RESOLUTION 2012-52, A RESOLUTION APPROVING A REVISION TO THE DEVELOPMENT PLAN FOR SIMMONS RIDGE PUD SUBDIVISION, LOCATED AT 4408 SOUTH CAROTHERS ROAD, BY THE CITY OF FRANKLIN, TENNESSEE.

SUBJECT: Resolution 2012-52, A Resolution To Approve The PUD Development Plan For Simmons Ridge On ± 88.67 Acres For 408 Attached And Detached Units On The Property Located At 4408 South Carothers Road

NAME OF PROJECT: Simmons Ridge PUD Subdivision, Development Plan, Revision 2

MOS 3+4 STAFF EXHIBIT

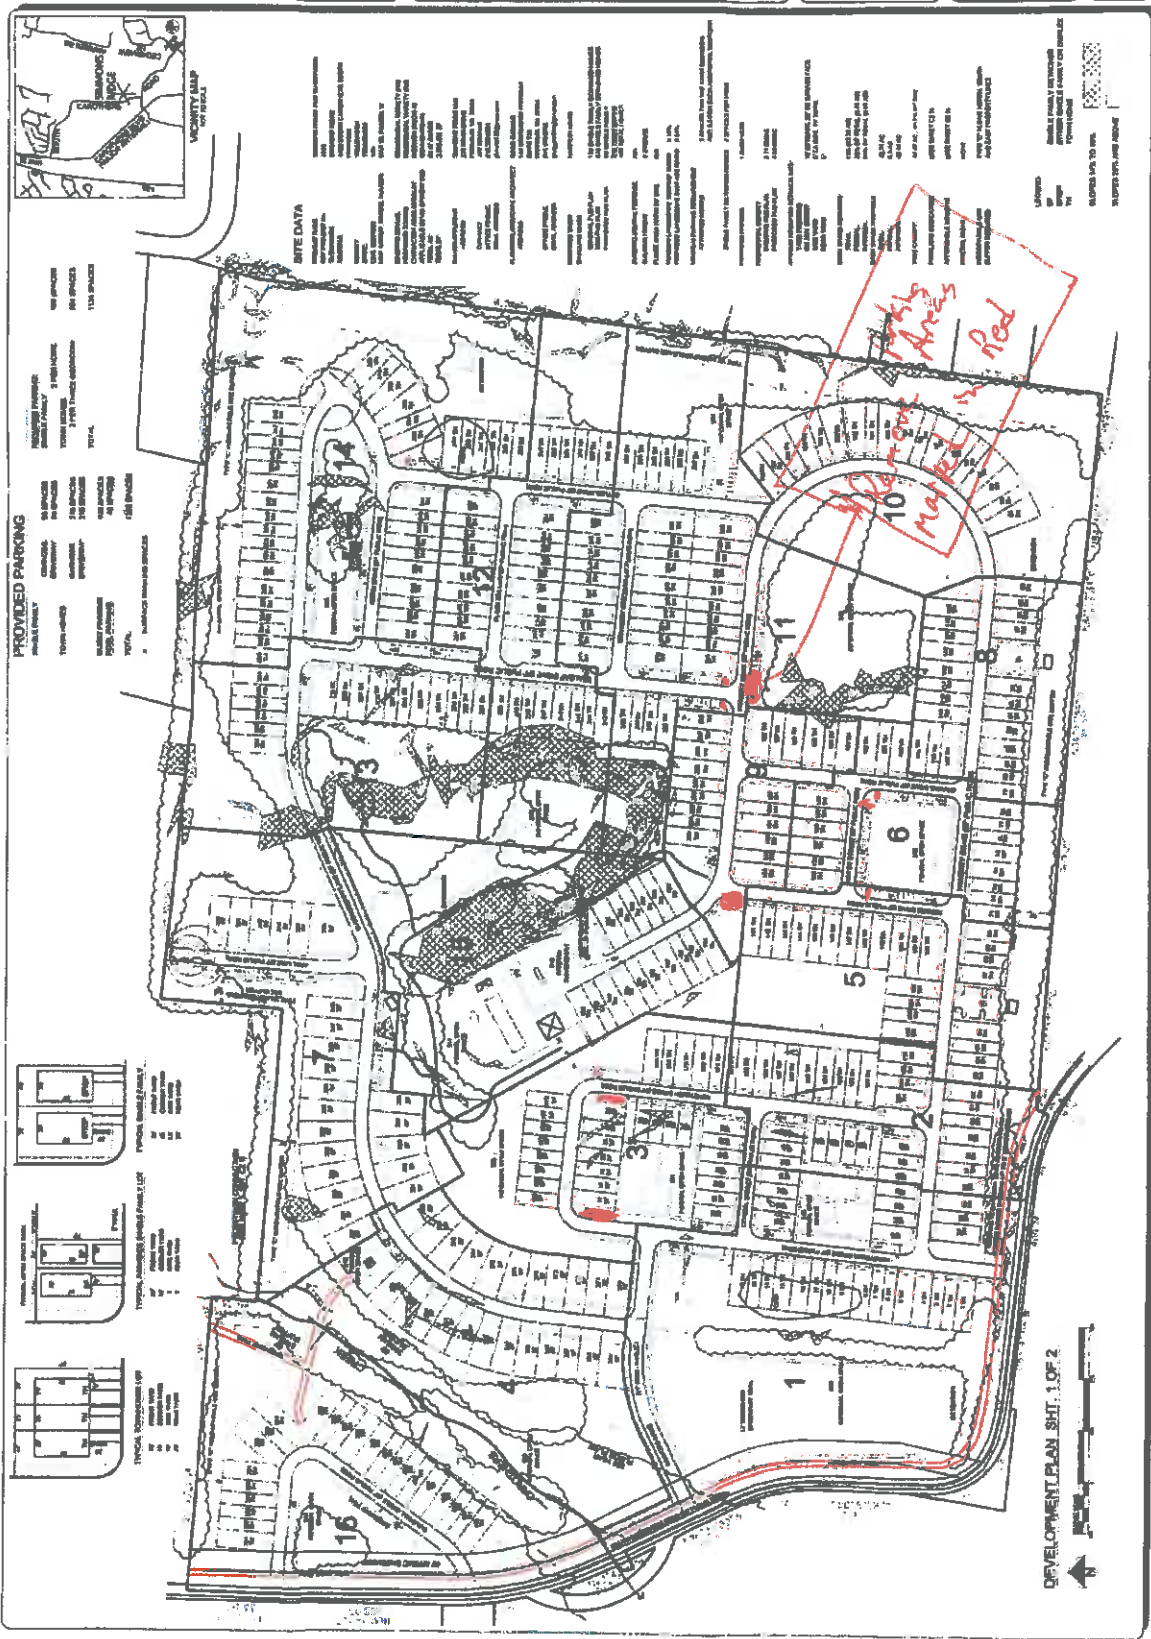
MOS 3/4 Backing onto a public street: Approve the applicant's modification of standards requests (MOS3/4) from Sections 5.9.3(4)(a)(iv) and 5.9.3(4)(b) to allow maneuvering incidental to parking in the public Right-of-Way and to allow backing from off-street parking onto public streets, with the exception of the parking spaces highlighted on the attached exhibit (MOS 3 & 4). The applicant shall update the parking calculations to account for the removal of these spaces. The plan shall meet the City's minimum parking requirement.

MOS 3/4 Backing onto a public street: Approve the applicant's modification of standards requests (MOS3/4) from Sections 5.9.3(4)(a)(iv) and 5.9.3(4)(b) to allow maneuvering incidental to parking in the public Right-of-Way and to allow backing from off-street parking onto public streets, with the exception of the parking spaces highlighted on the attached exhibit (MOS 3 & 4). The applicant shall update the parking calculations to account for the removal of these spaces. The plan shall meet the City's minimum parking requirement.
